SUBJECT: Forwards revised response to Question 410.48 re associated circuits. Response will be incorporated into FSAR in future amend.

Re: St. Lucie Unit No. 2
Docket No. 50-389
Final Safety Analysis Report
Response to ASB Question 410.48

EBASCO SERVICES INCORPORATED		FLORIDA POWER & LIGHT COMPANY	
DIV. _____	DR. E.M.	ST. LUCIE NO. 2	
DATE _____	CH. _____	APPROVED	
SCALE _____		ASSOCIATED CABLES	
			FIG-2C

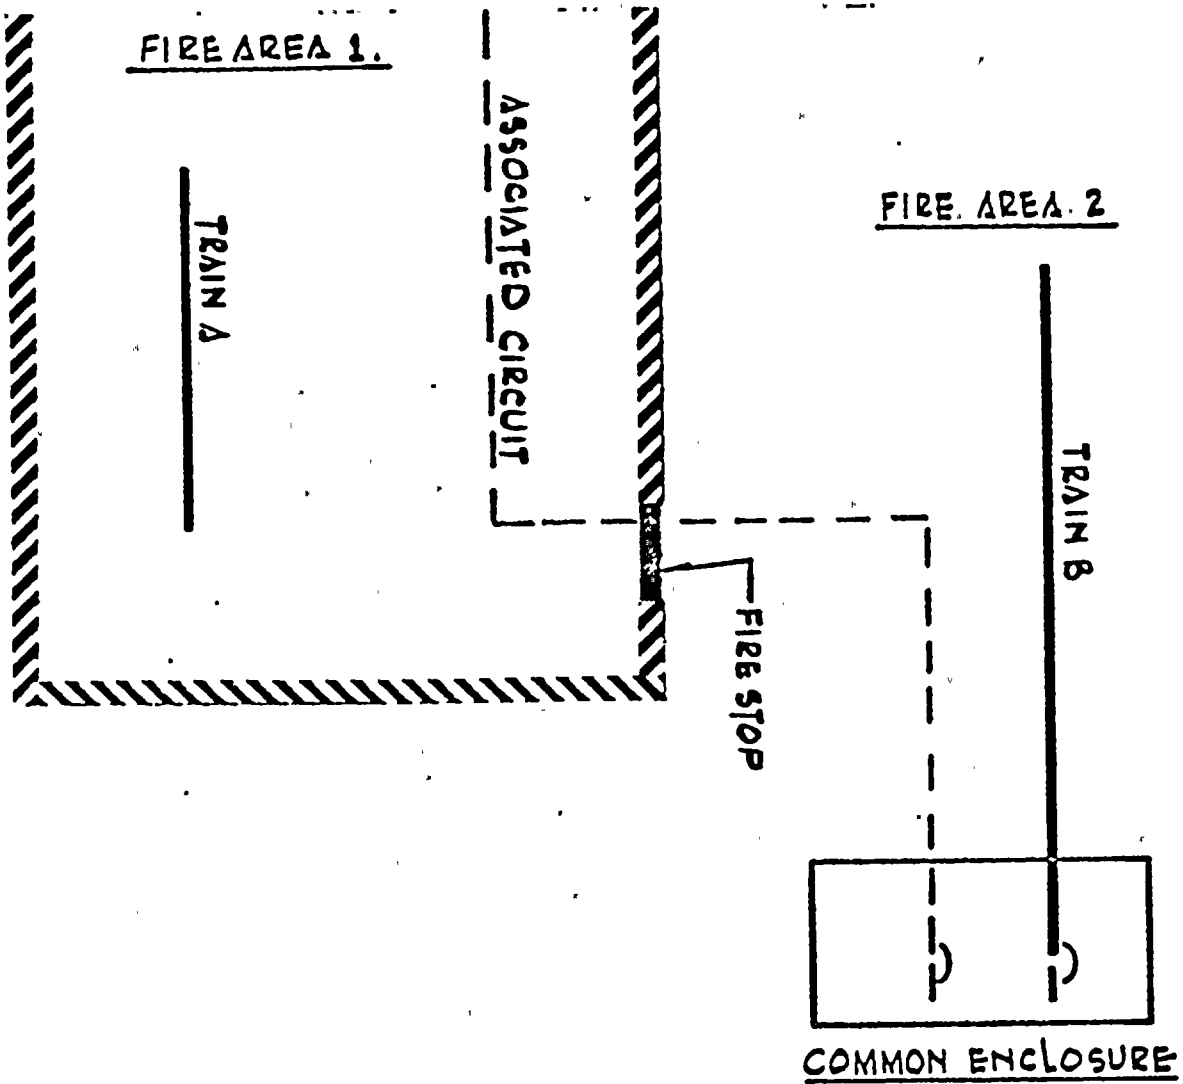
410.48 The documentation on associated circuits is incomplete. Enclosed is a staff position regarding associated circuits entitled "Associated Circuit Guidance. Using the staff position, provide a discussion of associated circuits which identifies each associated circuit and the means to protect these circuits for every fire area. A fire area is an area which is surrounded by three hour rated fire barriers, including floors, ceilings, floor to ceiling walls, and all penetrations.

For all circuits that do not meet the separation criteria of section III.G.2 of Appendix "R" and have a common enclosure, propagation of a fire into the common enclosure (see figure 2c attached) is prevented by the provision of fire stops at all fire boundaries and by the use of IEEE-383 qualified cable which will not propagate fire. In addition all circuits are protected by circuit breakers or fuses. Therefore, all circuits are excluded from the staff's definition of associated circuits as outlined above in item 2c. Three examples of non-essential components whose circuitry shares a common enclosure (MCC-2A5) with essential equipment are shown on CWDs 167, 270 and 522. Protection of the essential components is provided by circuit breakers and thermal overloads.

A FIRE IN FIRE AREA 1 WILL NOT AFFECT THE TRAIN B CABLES IN THE COMMON ENCLOSURE BECAUSE THE FIRE WILL NOT PROPAGATE INTO FIRE AREA 2 BECAUSE CABLES ARE FIRE RETARDANT AND A 3HR. FIRE BARRIER IS PLACED IN THE TRAY WHERE THE CABLE PENETRATES THE WALL.
